Summary of Comments and Responses

Project:	Drainage Consultancy Services for S.16 Planning Application at Lot Nos. 342 RP (Part) and 343 RP in D.D. 87, North New Territories, Hong Kong	Contract No.:	P24227 (Our Ref)
----------	---	---------------	------------------

Submission Reviewed:	Comments on the Drainage Proposal	Date:	05 March 2026
----------------------	-----------------------------------	-------	---------------

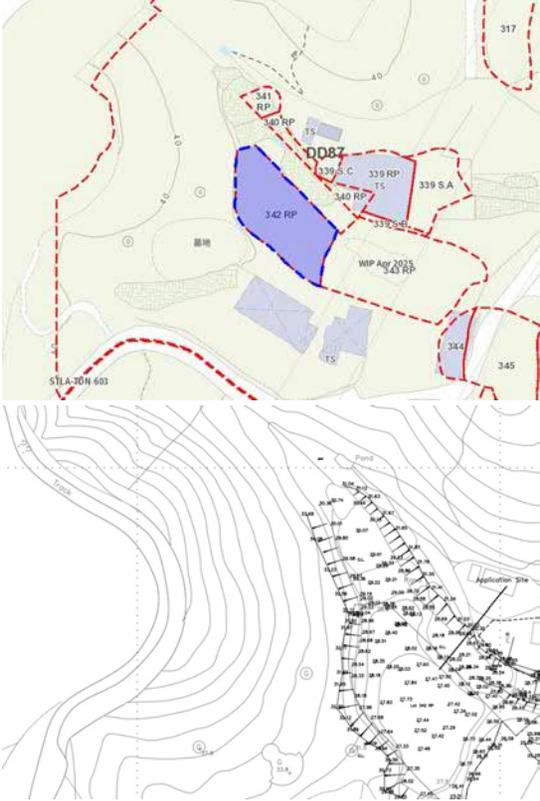
Item and reference	Comments	Wing's Response
7.	<p>For appendix D, please advise the principle used to demarcate Catchment Area 1. According to records, there is an existing streamcourse within Catchment Area 1. Please review if the current estimate of the external catchment area and incoming flow is adequate.</p>	 <p>From the record in GEOINFO and our topographic survey, there are no record of existing streamcourse. Therefore, the current estimation for catchment area 1 is adequate.</p>
8.	<p>For appendix D, the section views are missing. Please supplement them. Please also include the ground profile of the external catchment area in the section view for reference.</p>	<p>Section views are supplemented in Appendix D.</p>

CEDD Standard Drawing C1006C - Chain Link Fence

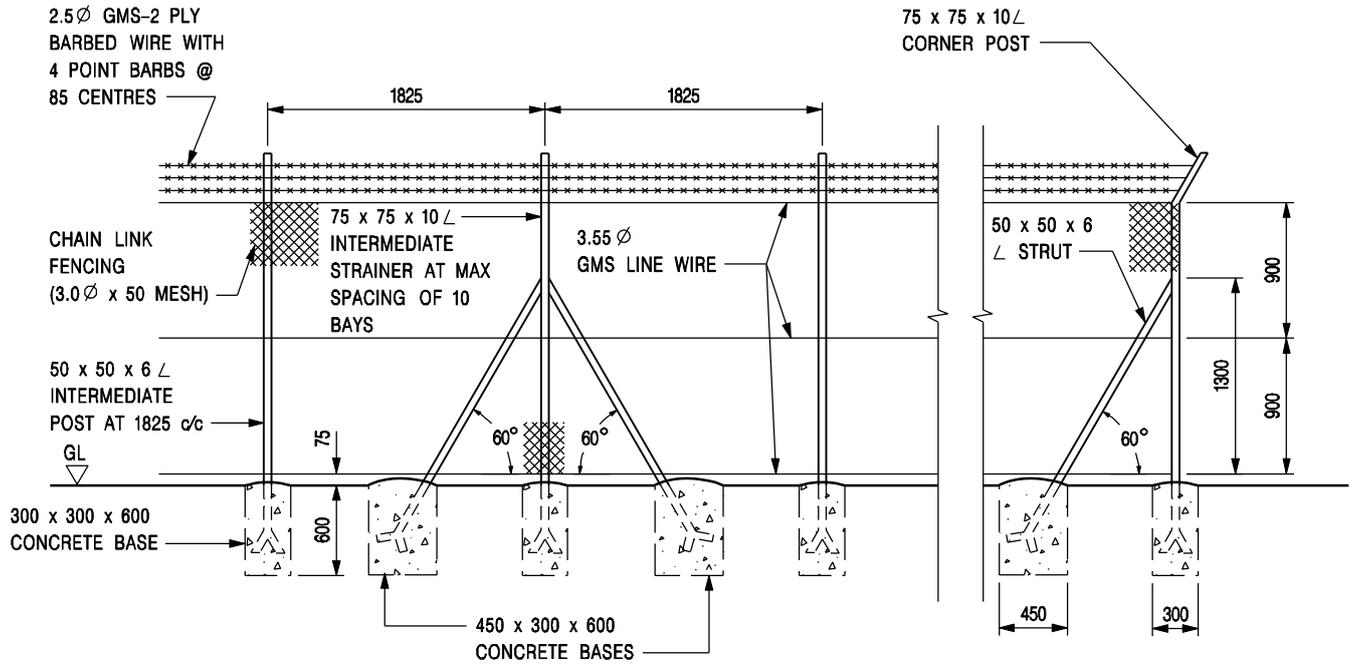
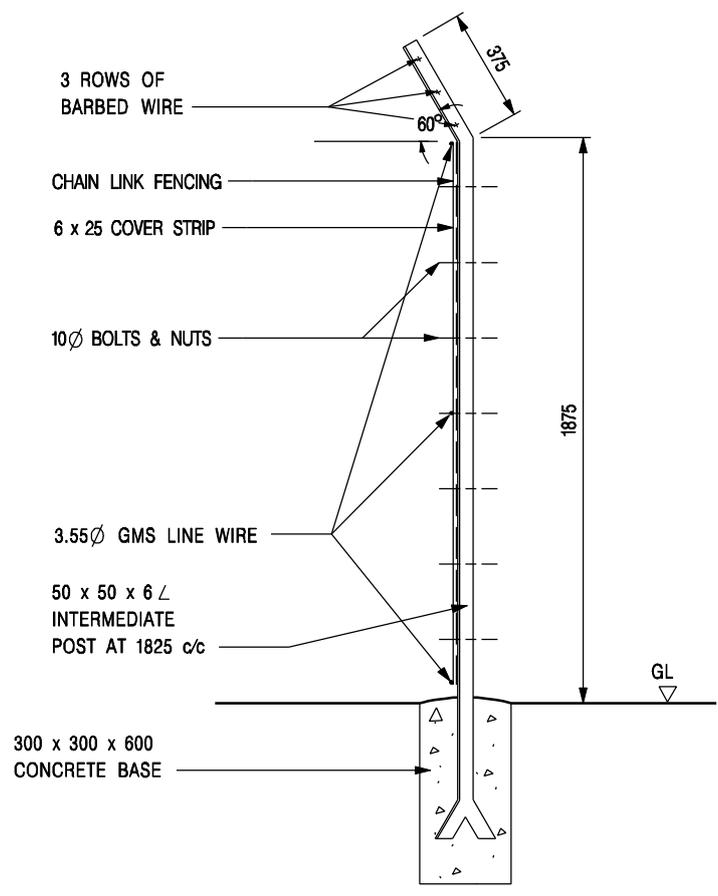
Item and reference	Comments	Wing's Response
9.	Please advise whether any land filling and construction of boundary walls are proposed. If yes, please show on a layout plan the alignment of the boundary walls and the existing and proposed ground levels, and assess whether the change in surface elevation and/or the erection of boundary walls will impede or alter the existing overland flow from adjacent catchments to the downstream drainage system. Please provide typical details of the proposed fencing to facilitate the existing overland flow from the external catchment area.	Boundary chain-link fence is proposed as part of the development. A minimum 75mm gap has been provided for the proposed chain-link fence wall, in addition, the hollow nature of the fence prevents any obstruction to the existing overland flow paths. Details of the proposed chain-link fence can be found referred to the attached CEDD Standard Drawing Any surface runoff entering the site through these gaps will be collected by the proposed internal drainage network, which has sufficient capacity to convey these flows for proper discharge downstream. Therefore, there will be no adverse impact on overland flow from adjacent catchments.
